As a part of reviewing the cost of obtaining and placing the riprap material from the off-site source, we also have taken the opportunity to update the equipment and labor rates used in the cost estimate calculations. In addition, we have revised the cover design to exclude the one-foot thick clay layer on the side slopes of the reclaimed area.

The reclamation cover design has been modified to exclude the use of the one foot thick clay layer on the side slopes of the reclaimed area. The clay layer is designed to reduce radon emanation from the stored tailing sands and therefore serves no purpose over the side slopes of the reclaimed area. The effect of this modification is to reduce the required volume of compacted clay by 28,410 yd³. The volume is replaced by a like amount of random fill, for a reduction in material and placement costs from \$7.98/yd³ for the clay to \$0.43/yd³ for the random fill. The overall reduction in cost is \$7.55/yd³ (\$214,500). The design modification is detailed on the attached revisions (Attachment 5) to Figures A-5.1-1, A-5.1-2 and A-5.1-3.

REV.	DATE	BY	REVISIONS	International Uranium (USA) Corporation White Mesa Mill	
1				FIGURE A-5.1-2	SHEET

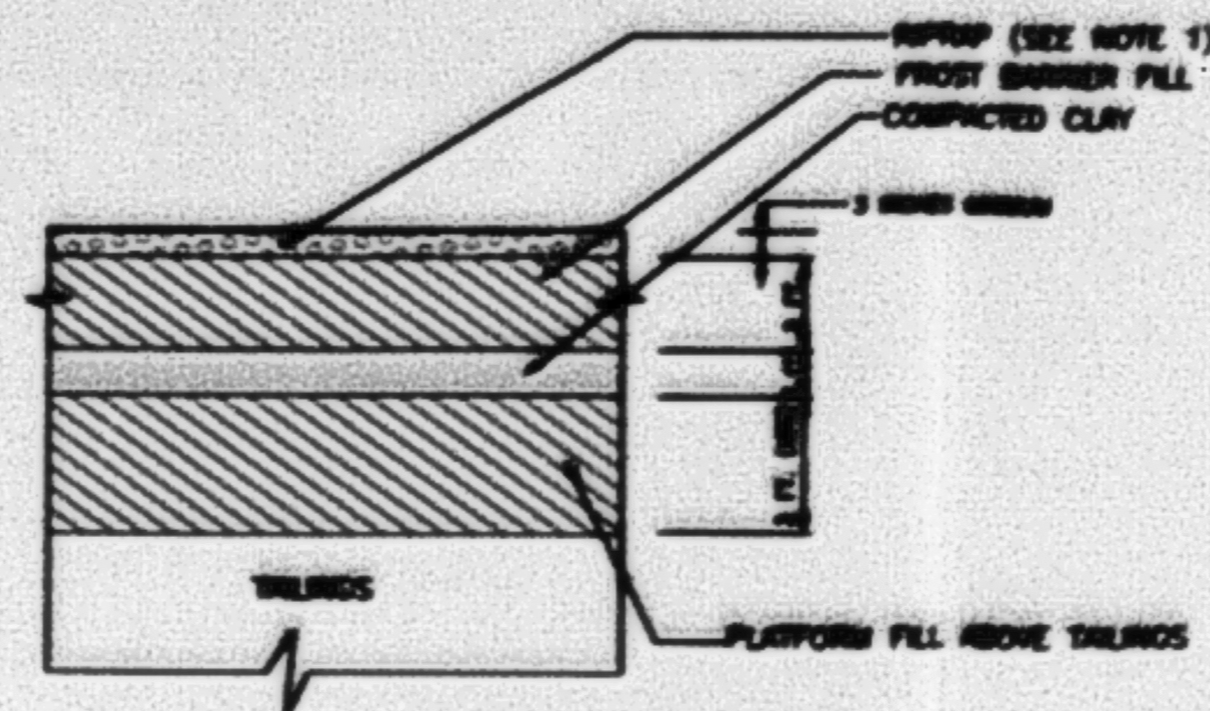
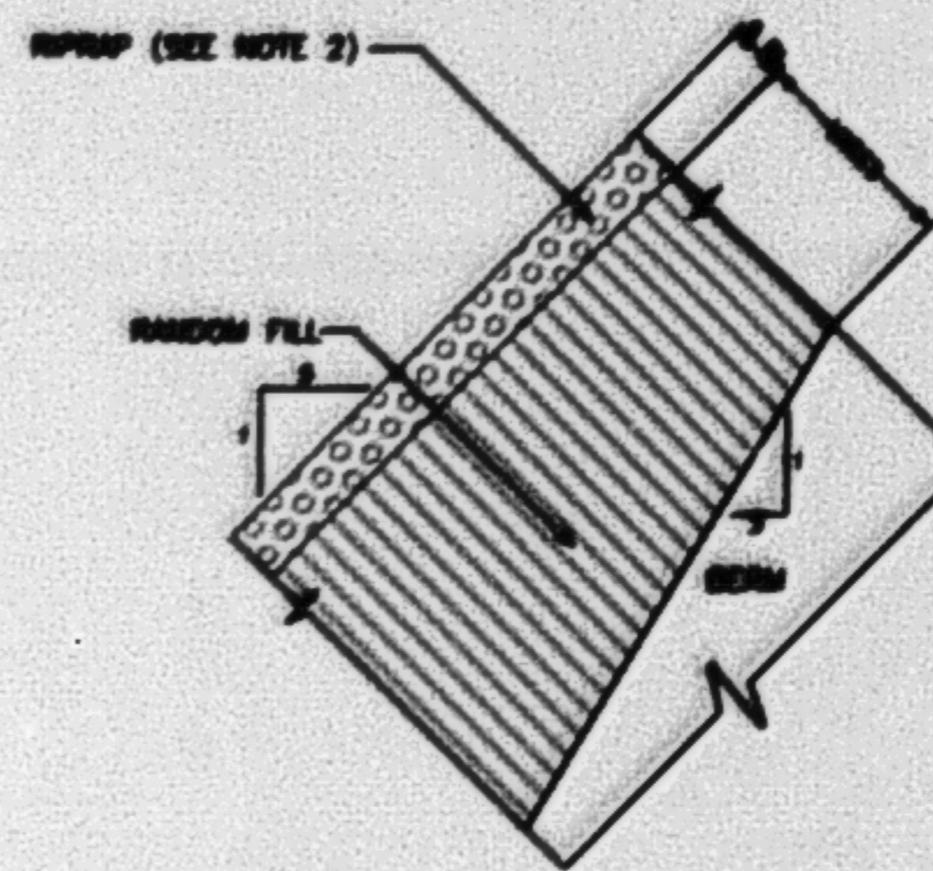
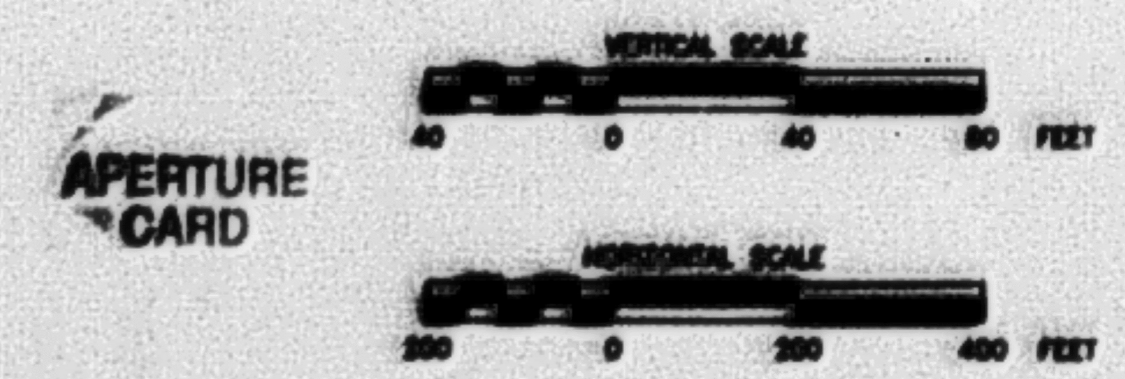
Note 5 Cost saving as a result of eliminating the 1 foot clay layer on the exterior side slopes. Ongoing field tests show that radon emanation rates from side slopes fall far below max allowed levels without the need of the clay layer
